CFC Percy St. Auburn

13 Percy Street, Auburn, NSW 2144

S4.55 - AMENDMENT LIST

ISSUE FOR S4.55

Drawing Title:
Elevations - Sheet 2

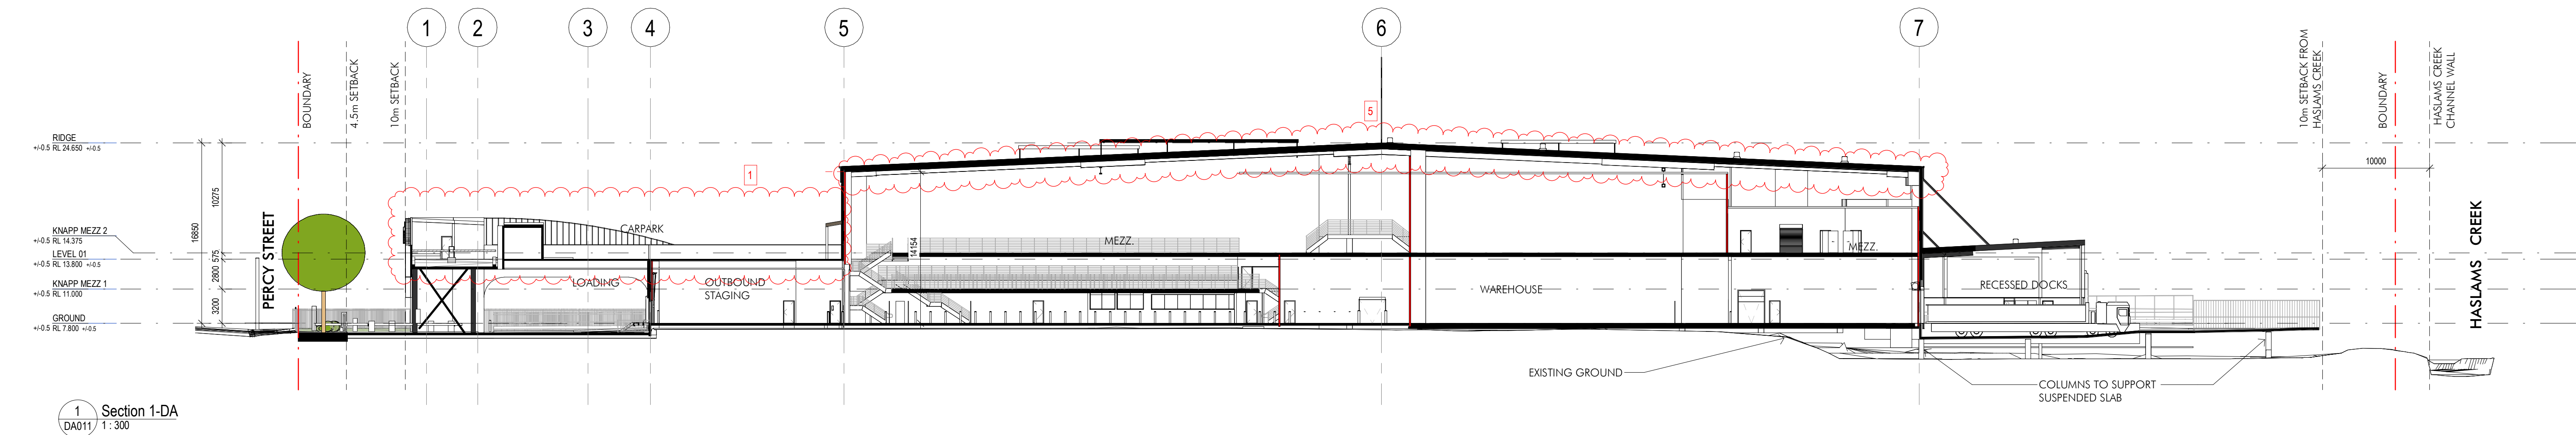
- Carpark layout change due to additional mech.plant rooms & boomgate
- Extension of roof over L1 office entry
- Added external egress stair, awning over DTB bays and plant deck

- Added external egress stair to access mezz. floors and roof
- Added mech. exhaust & plant on roof & removed translucent roof sheets
- Inbound dock awning is reduced

- Added mech & refrigeration plant rooms on rear elevated plant deck, and associated egress stair
- Added removal of existing concrete channel in demolition

- Additional DTB store and DTB bays, including changed configuration of DTB bays
- Office internal layout amended
- Added landscape area, aluminium screen & gates

- Southern plant area layout changed as following
 - Solar and switch room layout reconfigured
 - Sub & HVC updated
 - Permanent generator reduced to single large gen. Portable gen is added

- Diesel tank is added for backup generators
 - Armco is added around sub & sprinkler plant area
 - One (1) van parking relocated
- Precast wall is erected higher to support the rear elevated plant deck

- Maintenance and wash bays are added
- Added an external stair to inbound dock area
- Security gates added
- Boom gates added
- Minor enlarged L1 office lobby & additional stair next to rec area

- NOT USED
- Mech. Louvre added
- Heavy duty guardrail added to suspended slab edges
- Replaced transparent wall sheeting to Longline metal cladding
- Pickup graphic extended

- CFC sheeting is removed from Office ground elevation
- NOT USED
- Outbound Loading dock size & Van parking size increased (TBC)
- Two mechanical plant rooms on carpark level added

- Added 3 flag poles
- Added 2 lightning poles
- Added generator on slab above switch and solar rooms
- Sign 03 & Sign 04 amended
- Two (2) signs (Sign 06 & Sign 07) added

- South-east stair relocated

Drawing Title:
Sections

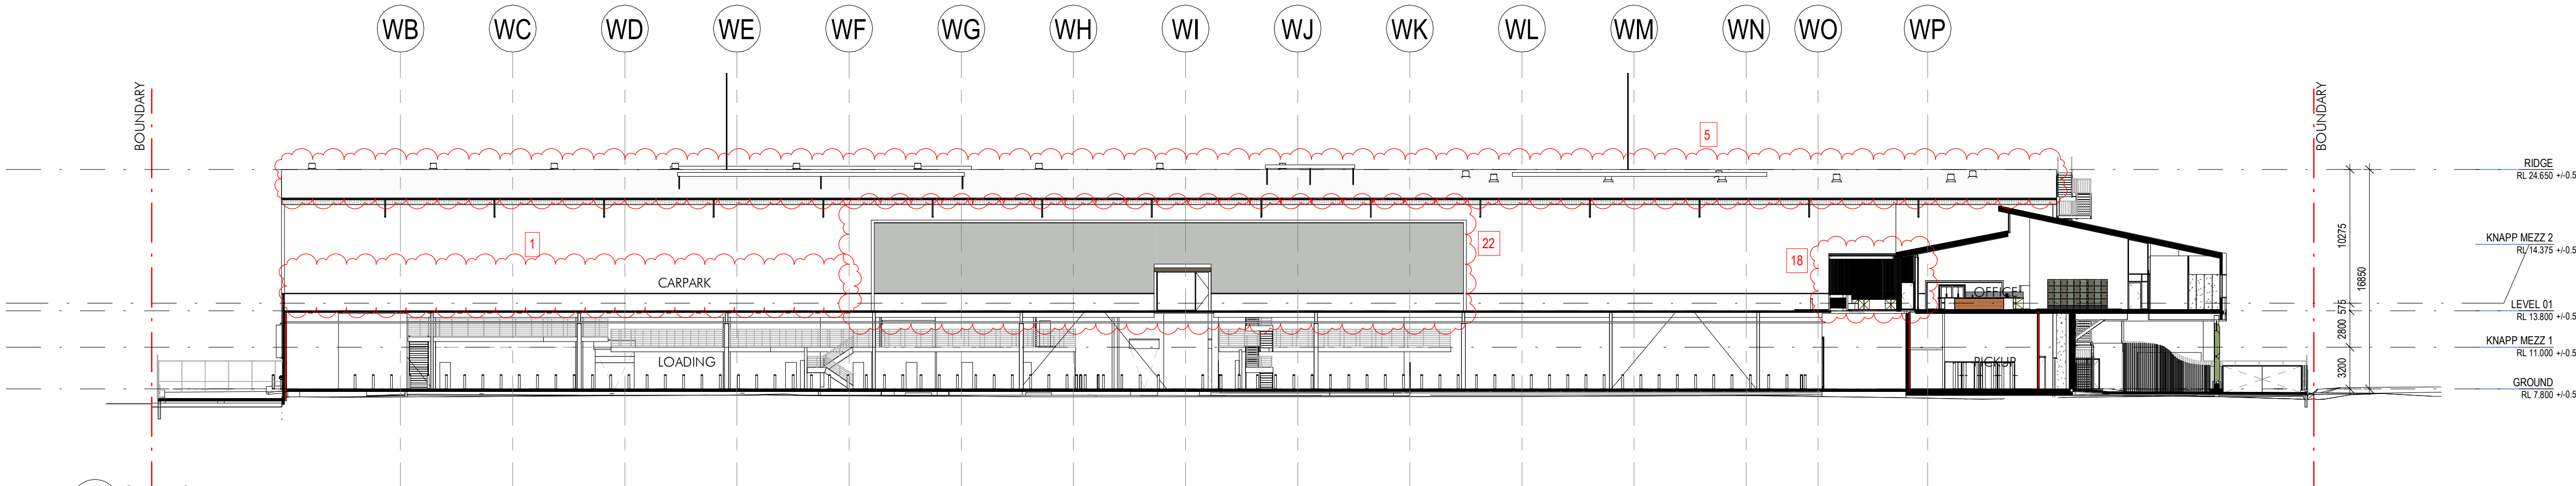
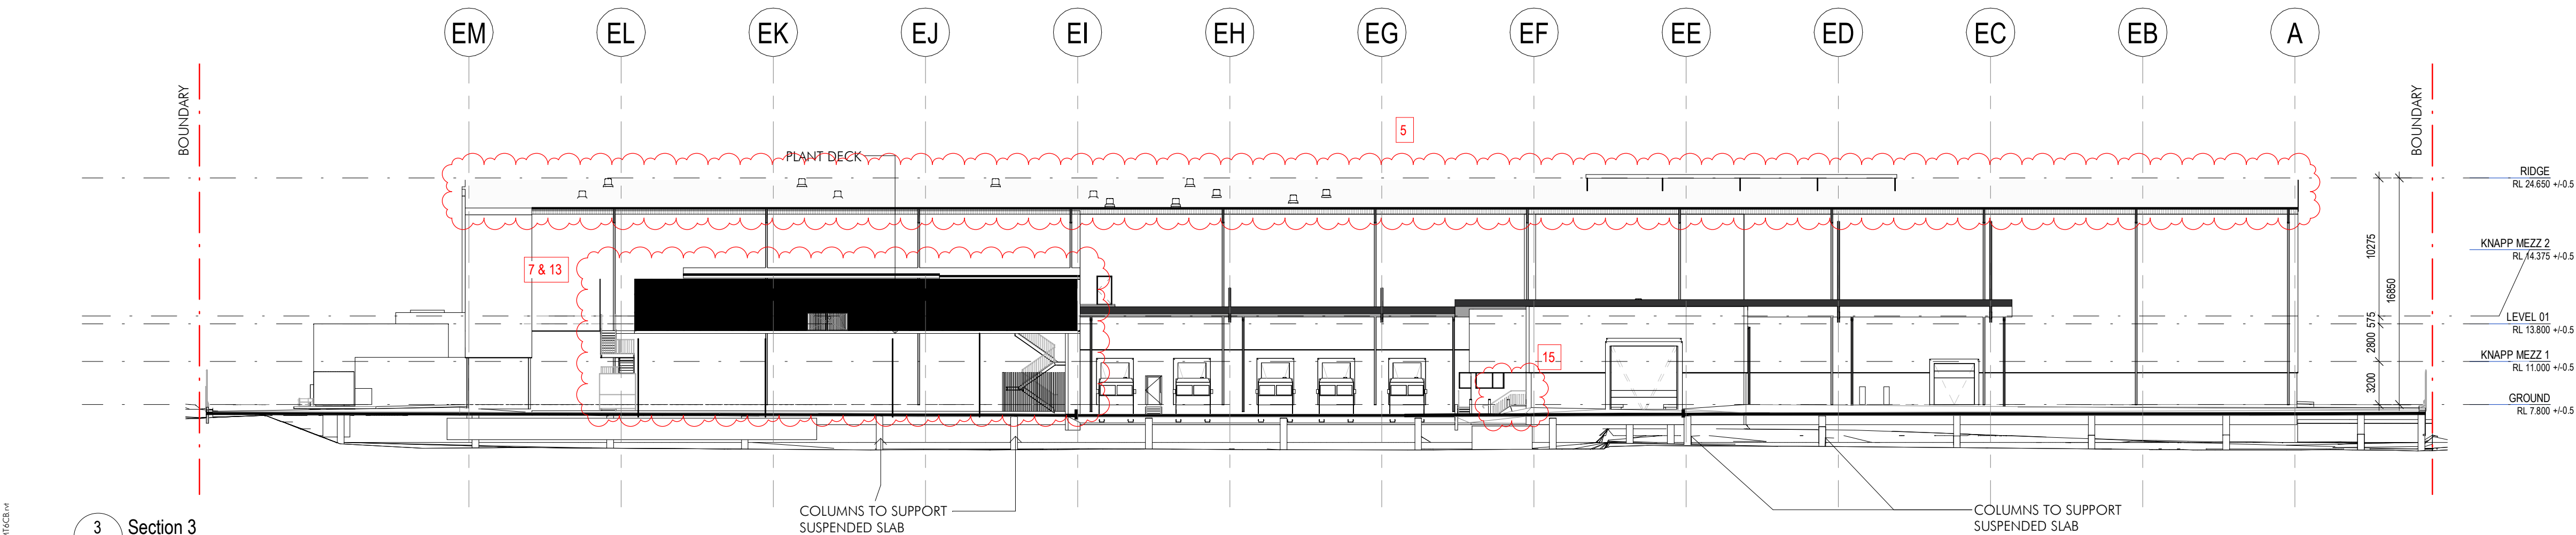
- Carpark layout change due to additional mech.plant rooms & boomgate
- Extension of roof over L1 office entry
- Added external egress stair, awning over DTB bays and plant deck

- Added external egress stair to access mezz. floors and roof
- Added mech. exhaust & plant on roof & removed translucent roof sheets
- Inbound dock awning is reduced

- Added mech & refrigeration plant rooms on rear elevated plant deck, and associated egress stair
- Added removal of existing concrete channel in demolition

- Additional DTB store and DTB bays, including changed configuration of DTB bays
- Office internal layout amended
- Added landscape area, aluminium screen & gates

- Solar and switch room layout reconfigured
 - Sub & HVC updated
 - Permanent generator reduced to single large gen. Portable gen is added
 - Diesel tank is added for backup generators

- Armco is added around sub & sprinkler plant area
 - One (1) van parking relocated
- Precast wall is erected higher to support the rear elevated plant deck

- Maintenance and wash bays are added
- Added an external stair to inbound dock area
- Security gates added
- Boom gates added
- Minor enlarged L1 office lobby & additional stair next to rec area

- NOT USED
- Mech. Louvre added
- Heavy duty guardrail added to suspended slab edges
- Replaced transparent wall sheeting to Longline metal cladding
- Pickup graphic extended

- CFC sheeting is removed from Office ground elevation
- NOT USED
- Outbound Loading dock size & Van parking size increased (TBC)
- Two mechanical plant rooms on carpark level added

- Added 3 flag poles
- Added 2 lightning poles
- Added generator on slab above switch and solar rooms
- Sign 03 & Sign 04 amended
- Two (2) signs (Sign 06 & Sign 07) added

- South-east stair relocated
